Approved for access by the Solid Waste Department.

EAGLE RANCH RETAIL  
SITE PLAN  
9641 EAGLE RANCH ROAD NW  
ALBUQUERQUE, NM 87114  
PROJECT #1620

AS-1.0

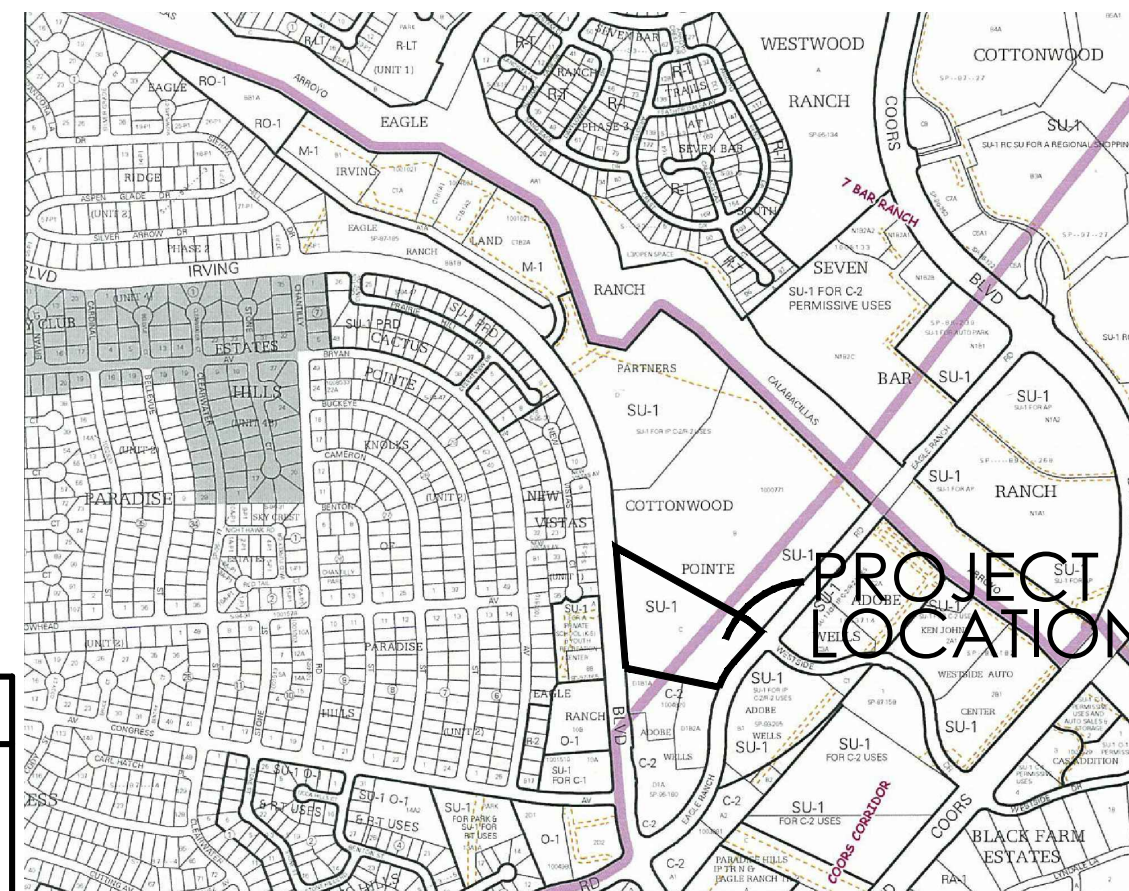
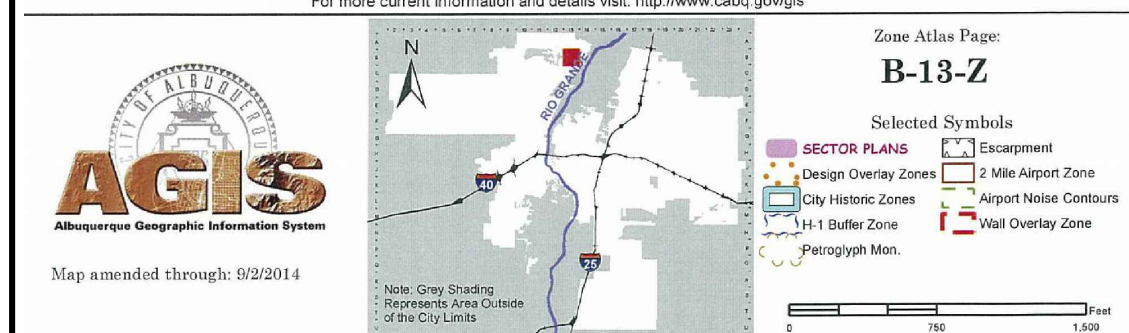
All containers must be made accessible for pick up

between the hours of 5AM and 8PM.

**\*\*No gates were approved under this submittal\*\***  
**\*\*The grease container will not be stored in the trash enclosure.\*\***
